Access Compliance Report

Public Rights-of-Way

(Curb Ramps)

Intersection ID: 29698	Main Street: SIMFIELD_CHURCH_RD	Cross Street: WOODCROFT_WY	Location: NE
ADA ID: F200532734F7	Ramp Type: PerpDiag	Initial Pass/Fail: Fail	Overall Compliance: No
Severity Score: 10			
Codes/Mitigation Info/Possible Solution		Field Measurements/Component Compliance

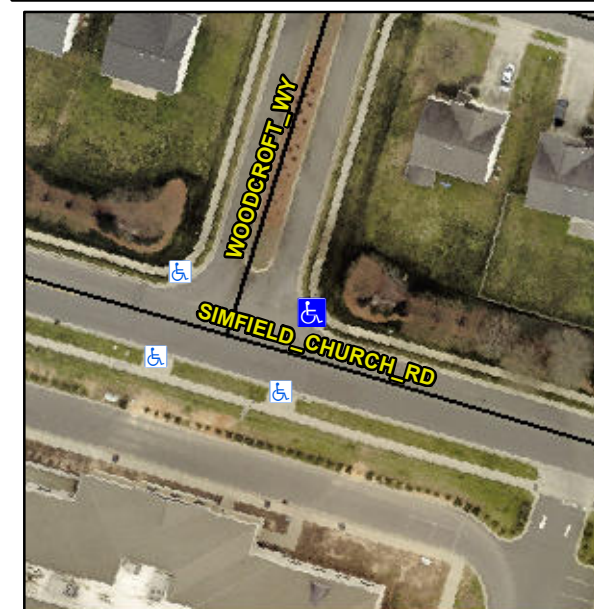
R304.5.1, R304.5.3

Compliance	Description	Data	Compliance	Description	Data
N/A	Ramp Length (in)	43.0	Yes	Ramp Slope (%)	6.8
No	Ramp Width (in)	45.0	No	Ramp XSlope (%)	2.9
N/A	Flare Type LT	N/A	N/A	Flare Type RT	N/A
N/A	Flare Slope LT (%)	N/A	N/A	Flare Slope RT (%)	N/A
N/A	Flare Traversable LT?	N/A	N/A	Flare Traversable RT?	N/A
N/A	Landing Length (in)	N/A	N/A	DWS Provided?	N/A
N/A	Landing Width (in)	N/A	N/A	DWS Contrast?	N/A
N/A	Landing Slope (%)	N/A	N/A	DWS Length (in)	N/A
N/A	Landing X Slope (%)	N/A	N/A	DWS Full Width?	N/A
N/A	Landing Curb? (Y/N)	N/A	N/A	DWS Offset (in)	N/A
N/A	Shared Landing?	N/A			
N/A	Gutter Ponding?	N/A	N/A	Gutter Slope (%)	N/A
N/A	Gutter Lip Ht (in)	N/A	N/A	Gutter X Slope (%)	N/A
N/A	Painted X Walk1?	No	N/A	Painted X Walk2?	No
	X Walk 1 Direction	To W		X Walk 2 Direction	To S
N/A	X Walk 1 Width (in)	N/A	N/A	X Walk 2 Width (in)	N/A
	X Walk 1 Slope (%)	2.0		X Walk 2 Slope (%)	0.1
	X Walk 1 X Slope (%)	1.4		X Walk 2 X Slope (%)	1.8

Remove & Replace Curb Ramp With Two New Directional Ramps or Equivalent.
